2002 Ford Mustang GT V8-4.6L SOHC VIN X

CONVERTIBLE TOP BOOT - POOR FIT

02-9-8

BODY - CONVERTIBLE TOP BOOT FIT

Figure 1

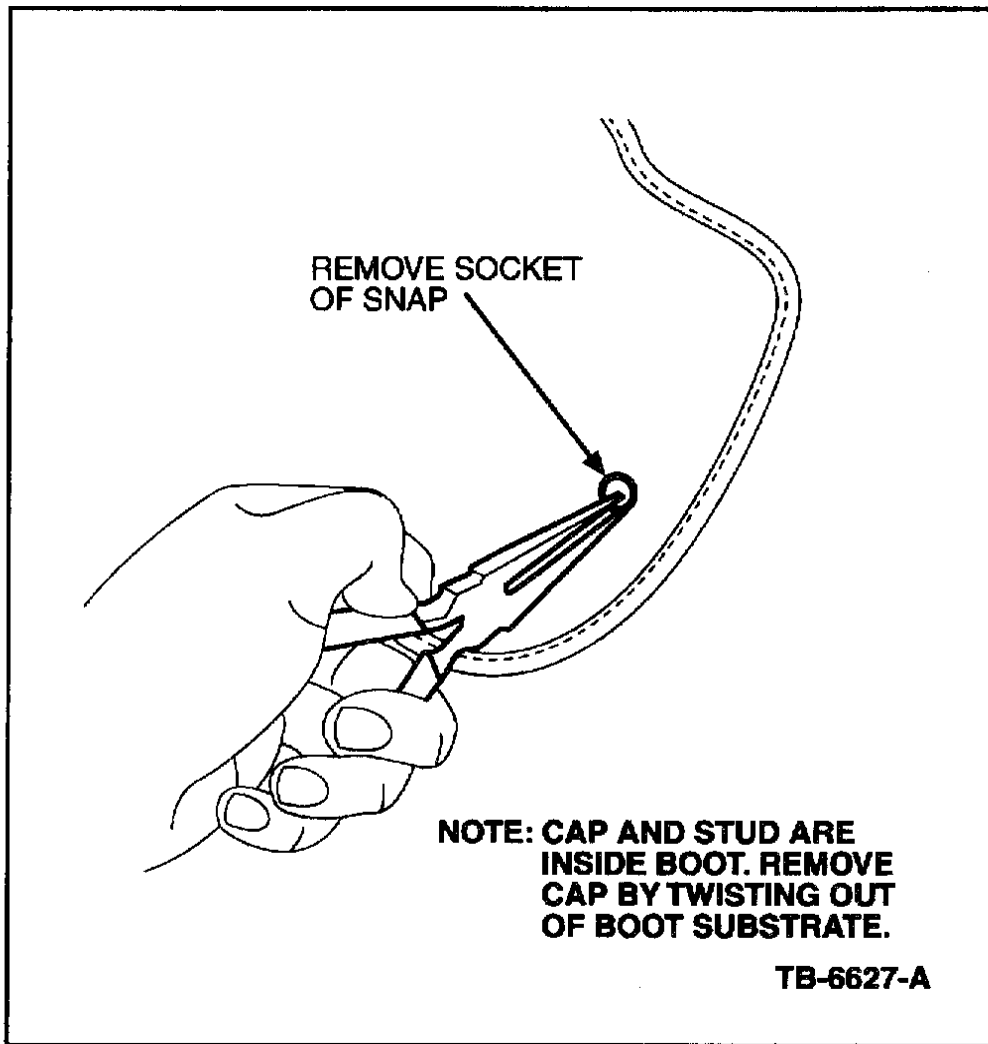
1. Using a pair of pliers, remove the socket of the snap, located on the convertible boot (Figure 1).
2. Remove the remaining portion of the snap, by grabbing the stud with the pliers and pulling it out of the substrate in a twisting motion.

Figure 2

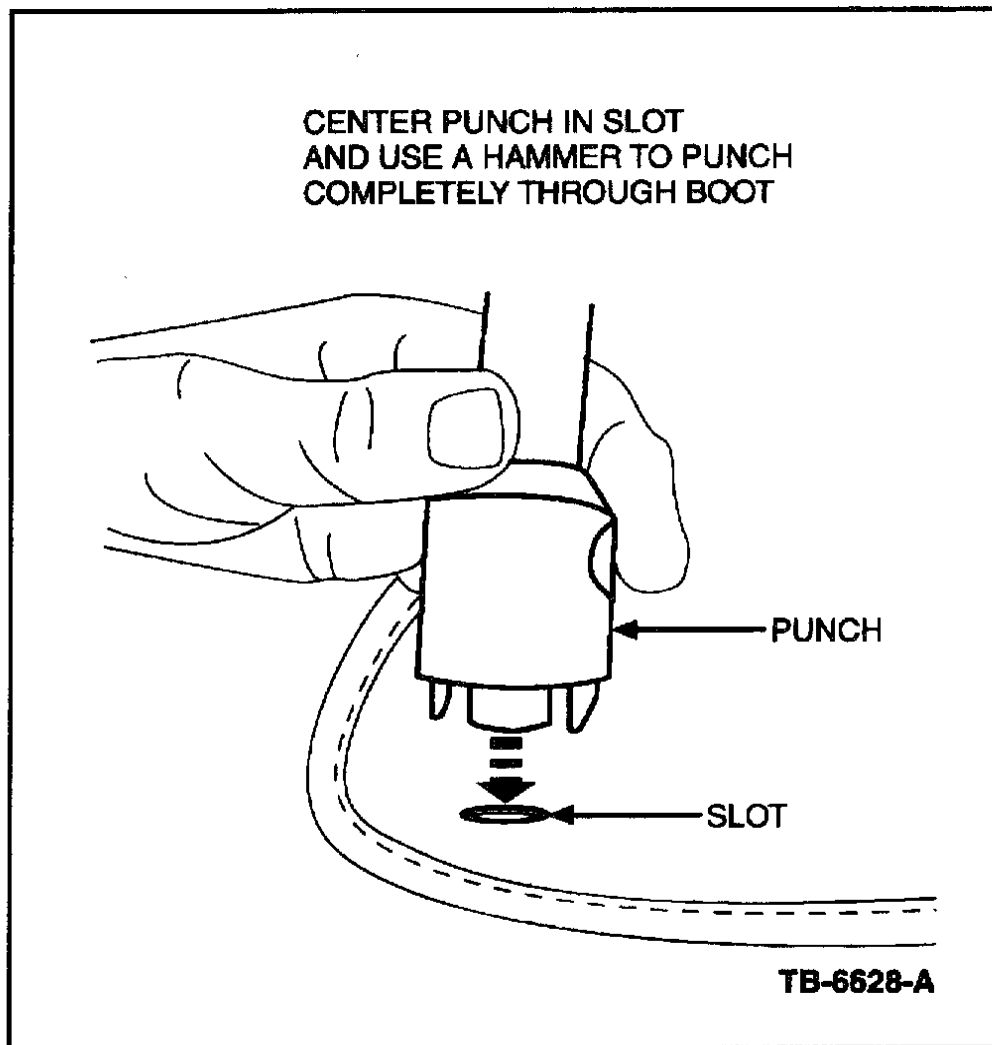
3. Locate the punch into the remaining slot (Figure 2) in the boot. Center the oval inside of the punch with the center of the slot. Lay the slot of the boot over a softer surface (ie. wood) and strike the punch with a hammer.
4. Verify that the punch has gone completely through the boot material.

Figure 3

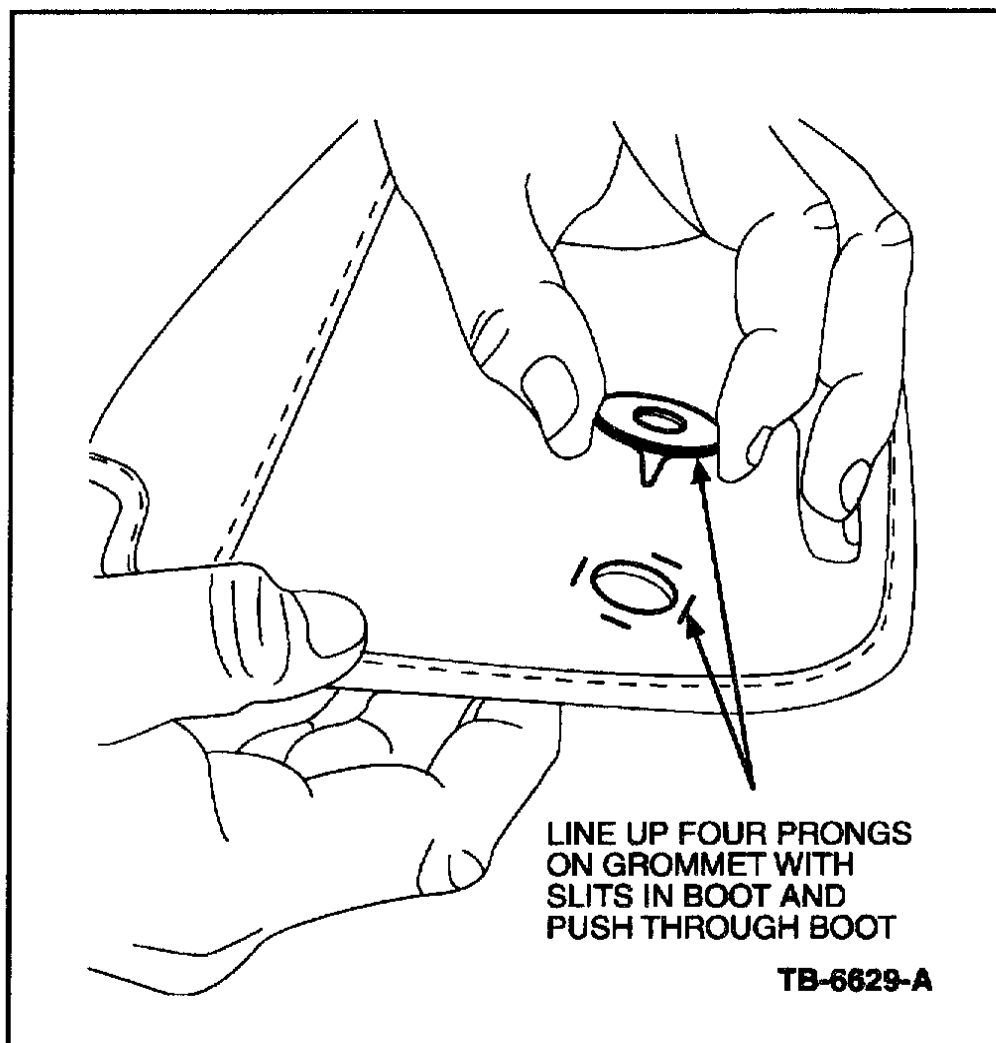
5. Line up the prongs on the grommet with the marks left by the punch teeth (Figure 3). Insert the grommet into the hole from the top side of the boot.
6. Verify that all four (4) prongs are protruding through the backside of the boot. Place the oval washer inside the prongs of the grommet.
7. Using your fingers or pliers, push the prongs of the grommet over the washer. Tap the washer with a hammer to fully seat the prongs.
